Dealer Notification	
SAFETY NOTICE	SN729
NHTSA Recall No.	24V-526

MODELS AFFECTED: XT Pro Aerial Device

SUBJECT: Replacement Basket Bracket

Figure 1. Compatible Components - Original basket bracket and original basket bracket retaining pins
 In production from 7/21/2014 through 7/30/2020

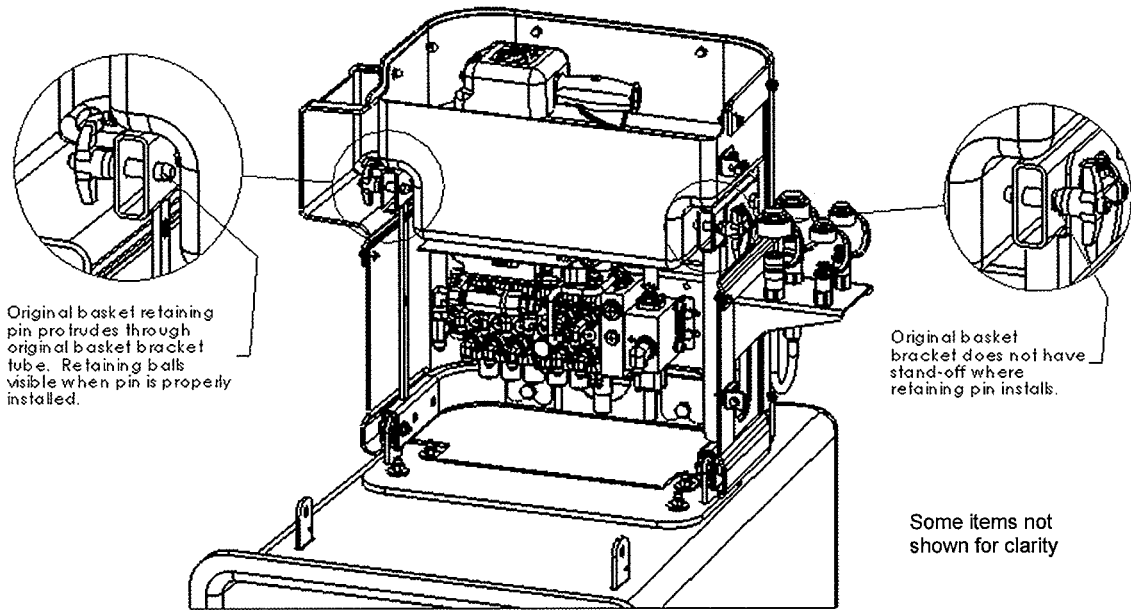
On the following pages are illustrations to show compatible and incompatible combinations of basket brackets and basket bracket retaining pins.

Figure 2. Incompatible Components - Replacement basket bracket and original basket bracket retaining pins

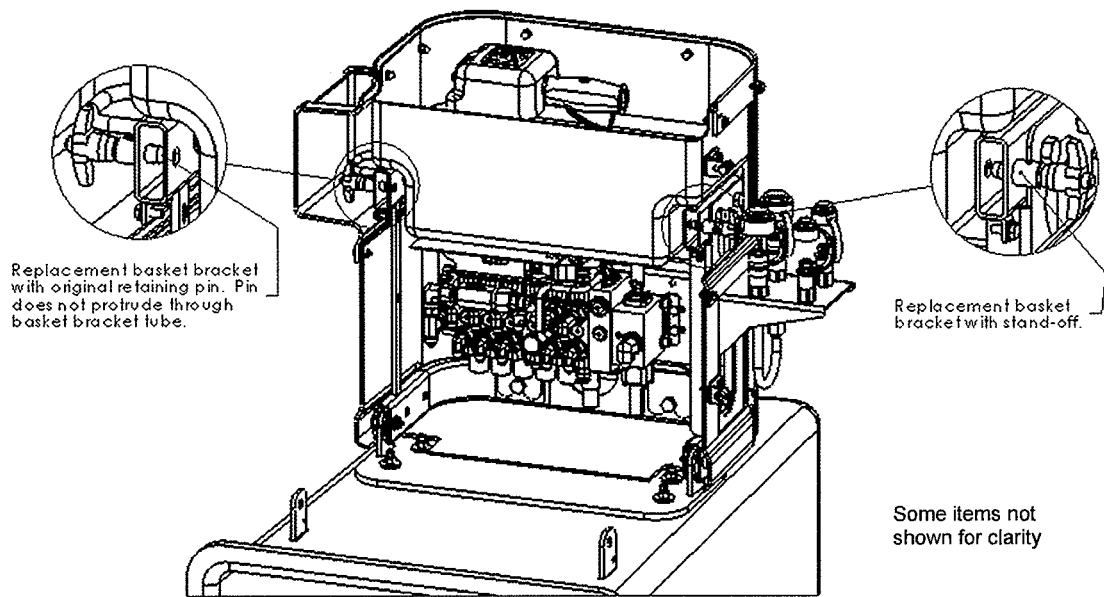
Models covered by this notice are certain XT Pro model aerial devices equipped with replacement basket brackets purchased from November 19, 2020 through June 10, 2024. Replacement basket brackets may not be compatible with the original basket retaining pins. If both basket retaining pins disengage, the basket may tilt. Tilting of the basket may cause the basket occupants to fall resulting in injury.

The retaining balls on the original basket retaining pins may not be able to withstand the force applied to them when installed in the replacement basket bracket, which may cause the pins to disengage.

Terex will provide Field Service Kit Z1724, parts and labor, at no cost to the purchaser of the replacement brackets. The Field Service Kit Z1724 provides basket retaining pins and hardware to replace the original basket retaining pins. The Field Service Kit Z1724 is estimated to be available no later than August 23, 2024.

Figure 4. Compatible Components - Replacement basket bracket and compatible basket bracket retaining pins
In production from 4/22/2020 through present day

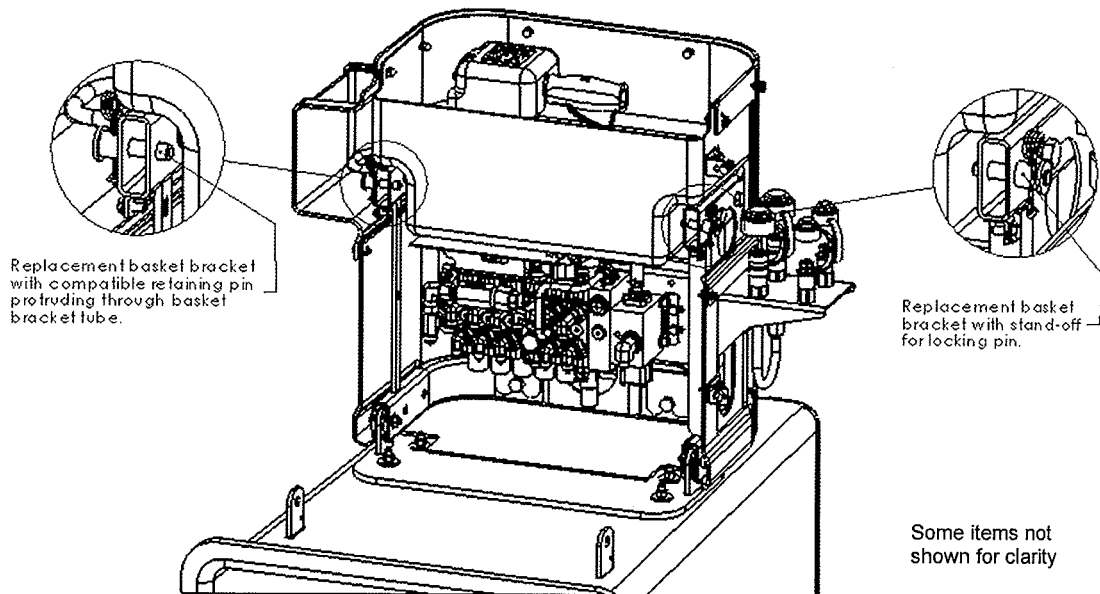
The remedied basket brackets will contain two basket retaining pins that visibly extend through the basket bracket tube. The original basket retaining pins on the recalled basket brackets will not visibly protrude through the basket bracket tube.
